*Am - 5 to
DPR - 64*

The Commission has issued the enclosed Amendment No. 26 to Facility Operating License No. DPR-26 and Amendment No. 5 to Facility Operating License No. DPR-64 for the Indian Point Nuclear Generating Units Nos. 2 and 3, respectively. These amendments consist of changes to the Technical Specifications for each license in response to your applications transmitted by letters dated August 27, 1976 and November 9, 1976. As discussed with your staff, modifications have been made to your proposed changes to meet regulatory requirements.

These amendments revise the Technical Specifications to change requirements for administrative controls.

INDIAN POINT NUCLEAR GENERATING UNITS NOS. 2 AND 3

Figure 6.2-1 Facility Management and Technical Support Organization

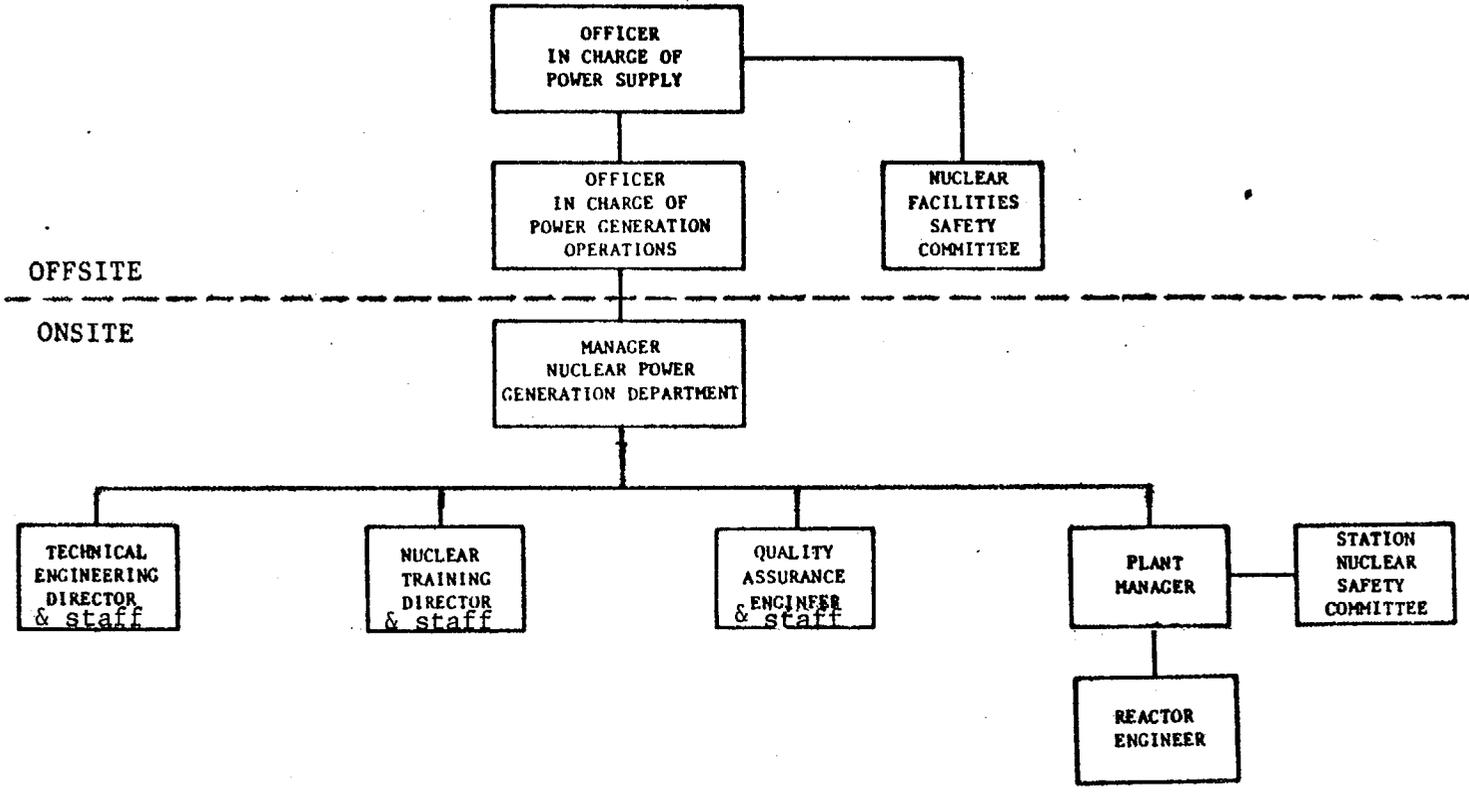
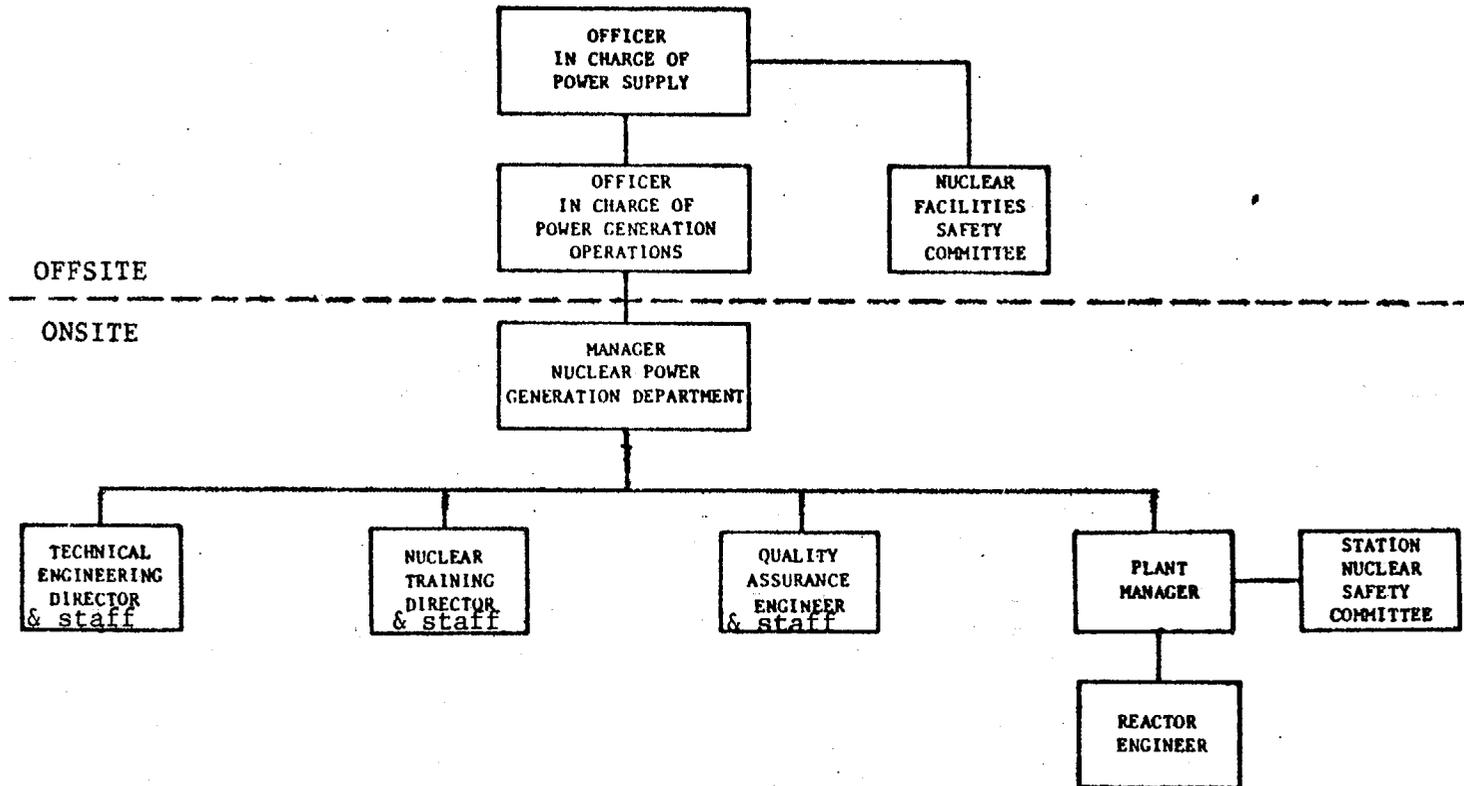
Changes were made in the organizational charts (figures 6.2.1 and 6.2.2) to more clearly reflect the fact that certain engineers and directors had staffs reporting to them. The composition of the Station Nuclear Safety Committee was modified to include the Manager, Nuclear Power Generation as a member. The highest level on-site manager would therefore be more directly informed of safety considerations and would also participate in such considerations by the committee.

6.2.1 The organization for facility management and technical support shall be as shown on Figure 6.2-1.

6.2.1 The organization for Facility Management and Technical Support shall be as shown on Figure 6.2-1.
